RICHMOND COMMUNITY SCHOOL
Richmond High School: Mechanical Modernization Project
LWC Commission No. 20104.02

ADDENDUM #03
October 3, 2021

Comm. No.	Date	08.27.2021
Drawn	Drawing No.	E301A
Checked

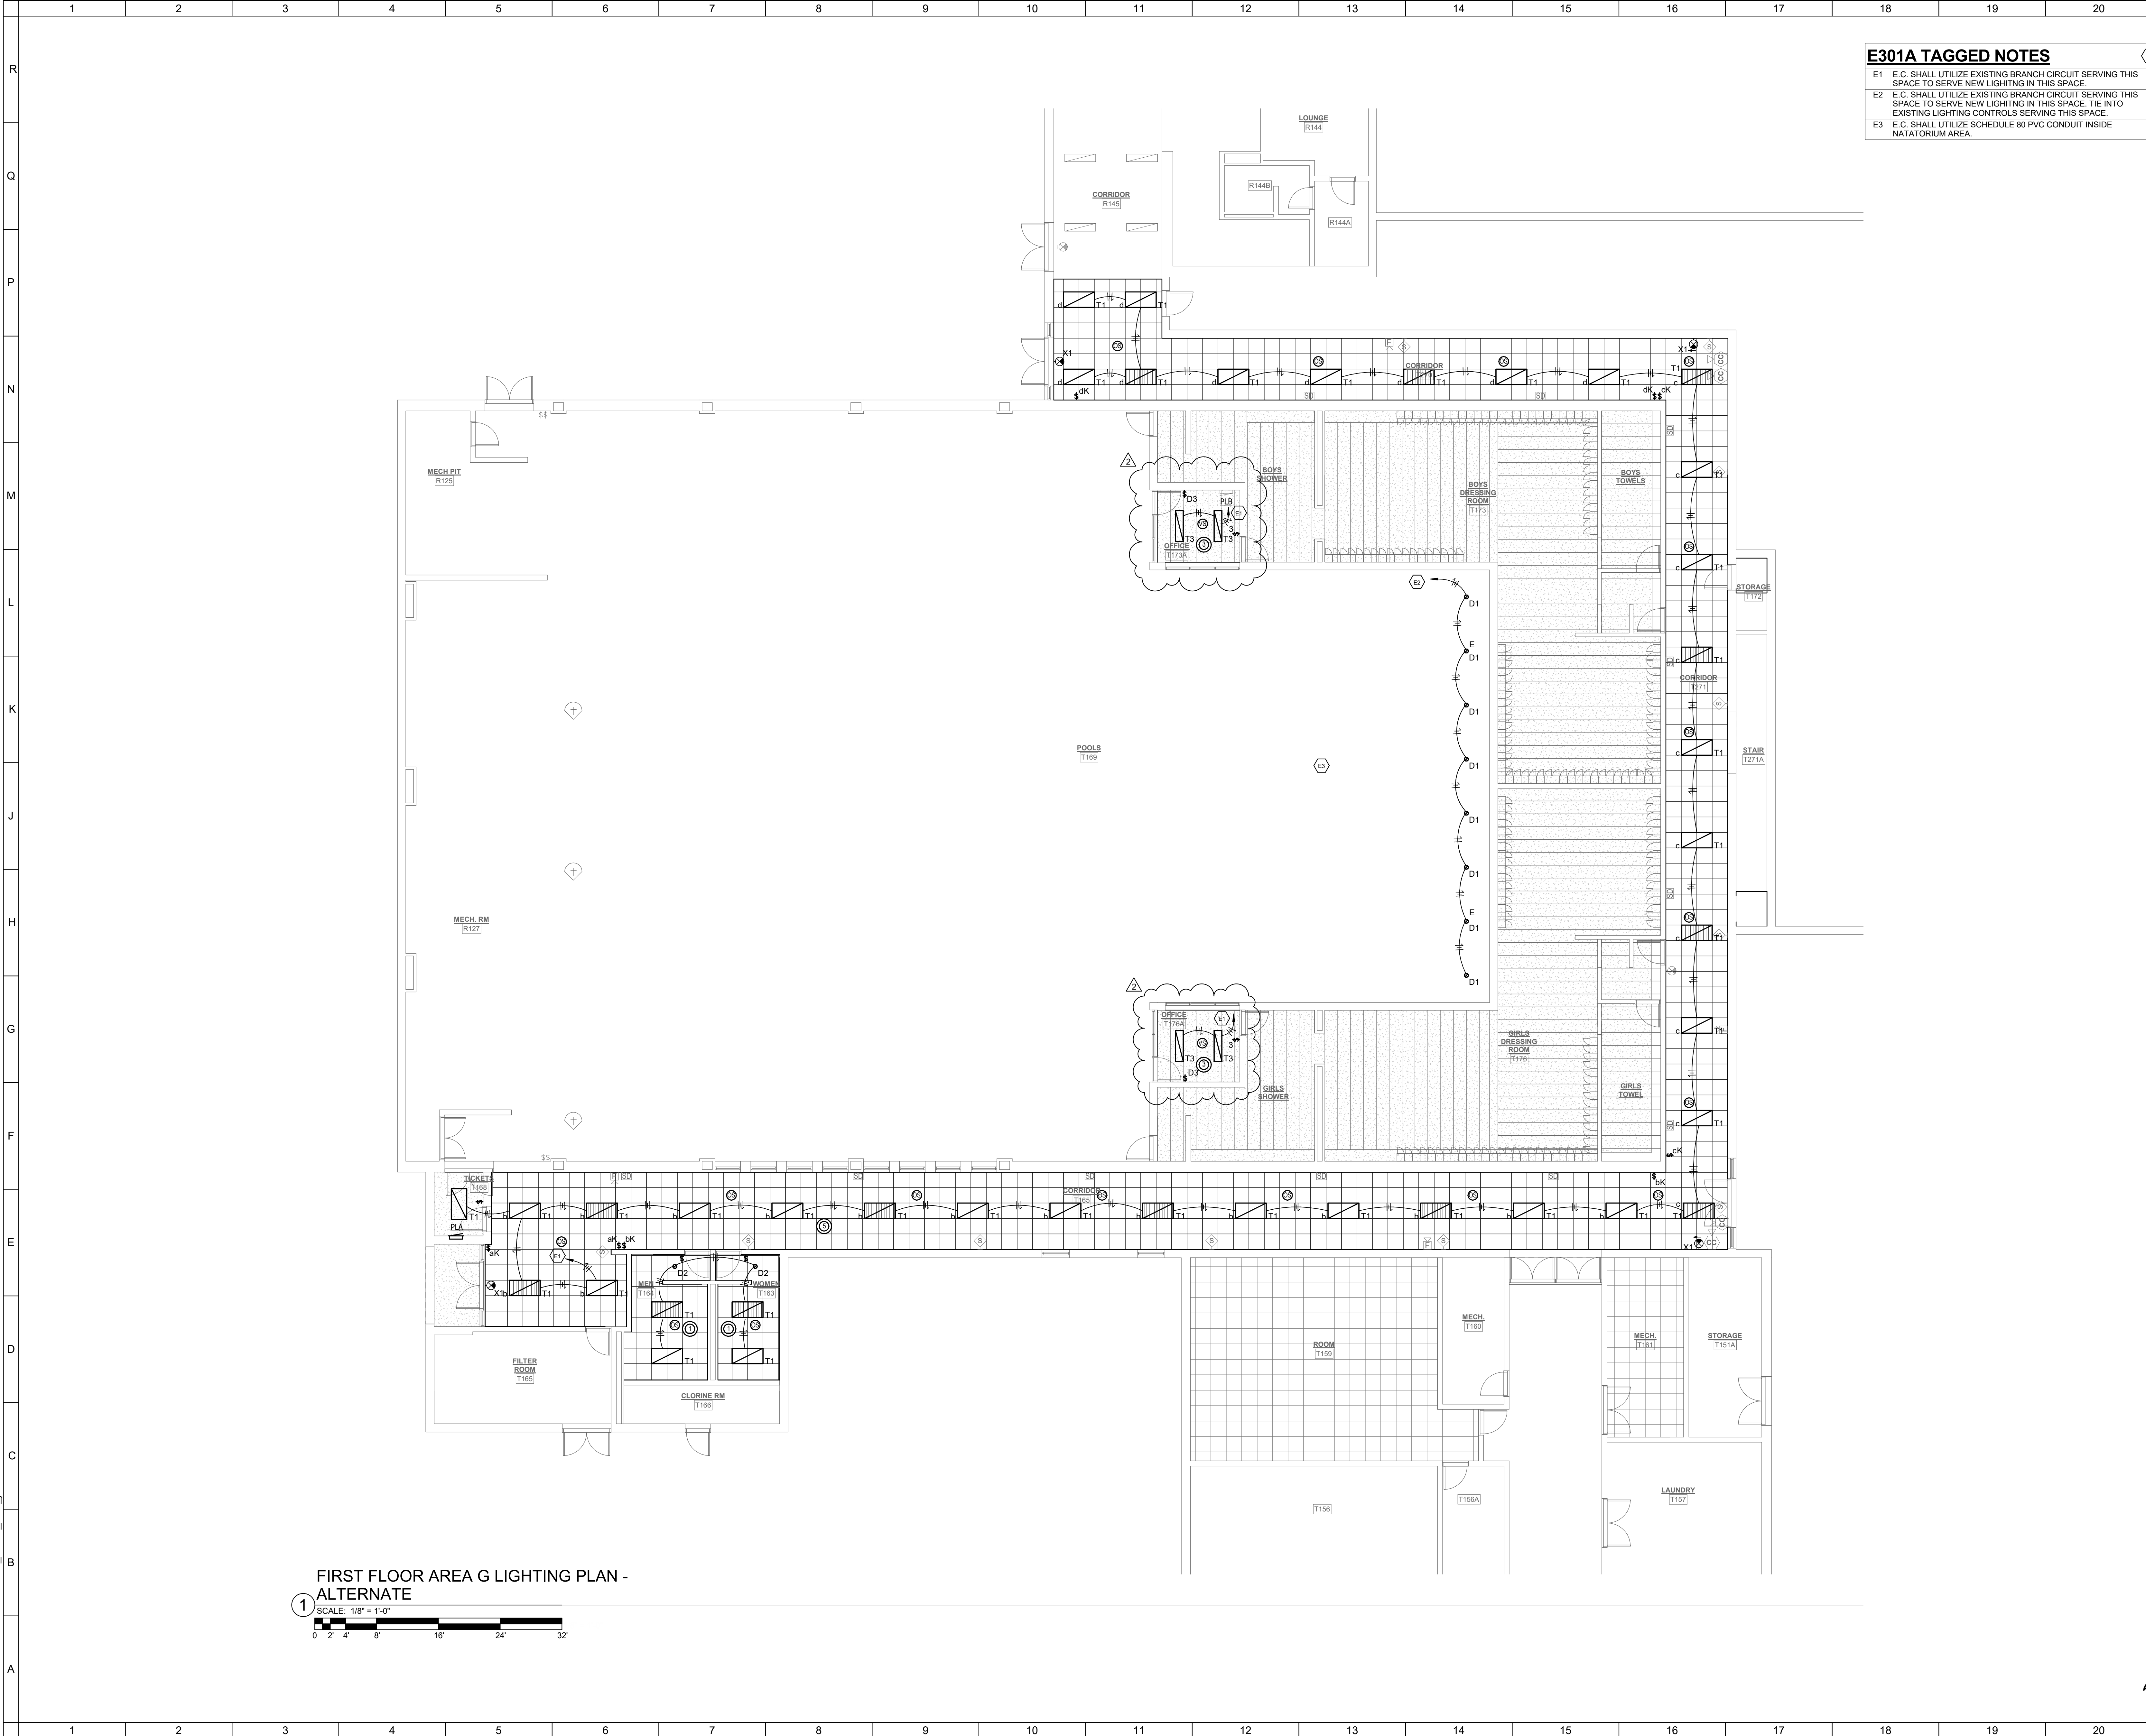
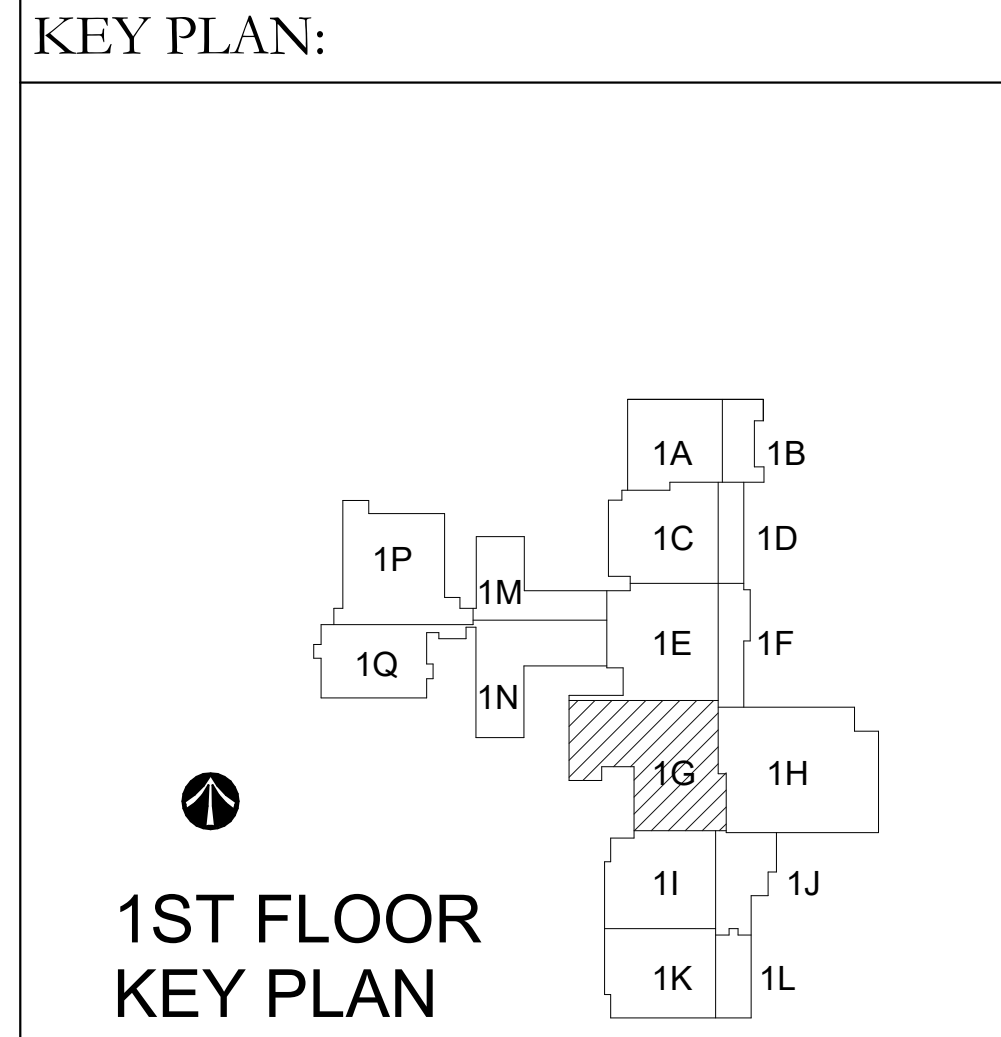
ITEM NO.14 Drawing E301A

- A. Added lighting and lighting controls to natatorium offices T173A and T176A.
